Flight Procedures Cover Page	Task Action: FLIGHT CHECK	Task Type: IAP	Estimated Chart Date: 10/02/2025	APWS Task ID: 2AABEC44C77B4A95B28697221A49B3FA	APWS Project ID: 4A8B836C90834922BA64FC3817AA43B9
Procedure: VOR RWY 5 AMDT 5		Enroute: NO	Specialist: Pipkin, Ryan		Agreement Number:
Airport ID: KEDN			Airport City: ENTERPRISE		State: AL
Facility ID: EDN	Facility Type: VOR	Flight Inspection Remark Type: New FC Slot			
Procedure Comments: DEVELOPED USING ACTIVE AIRNAV AIRPORT AND RUNWAY DATA FOR KEDN. BVG NDB DECOMMISSIONING. CONTACT RAKE MCGRAW (AJV-A422)- 405-954-8711 QUALITY 41 CHECKED QUALITY 34 CHECKED

VOR RWY 5
ENTERPRISE MUNI (EDN)

VOR RWY 5

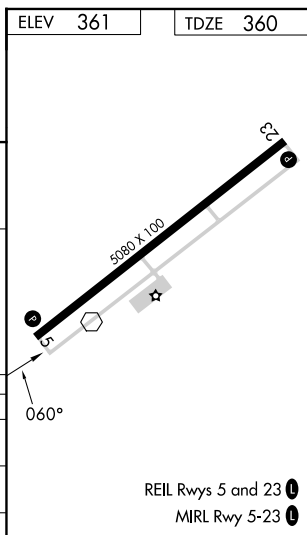
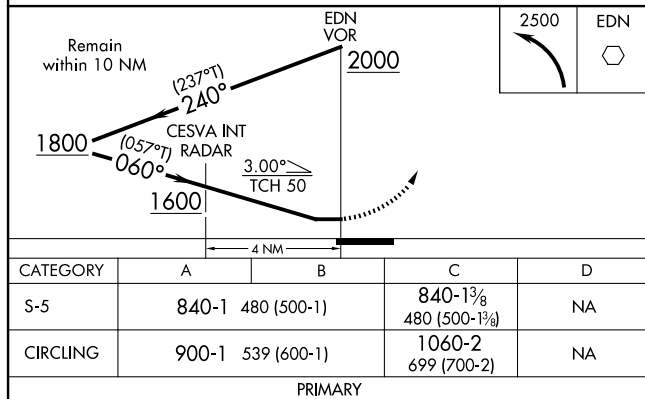
▼ ▲ NA ADF or RADAR required. Use Cairns AAF (Fort Novosel) altimeter setting.	MISSED APPROACH: Climbing left turn to 2500 in EDN VOR holding pattern.
---	---

MISSED APPROACH: Climbing left turn to 2500 in EDN VOR holding pattern, continue climb-in-hold to 2500.

T Circling Rwy 23 NA at night. When local altimeter setting not received, use OZR altimeter setting and increase all MDAs 40 feet.
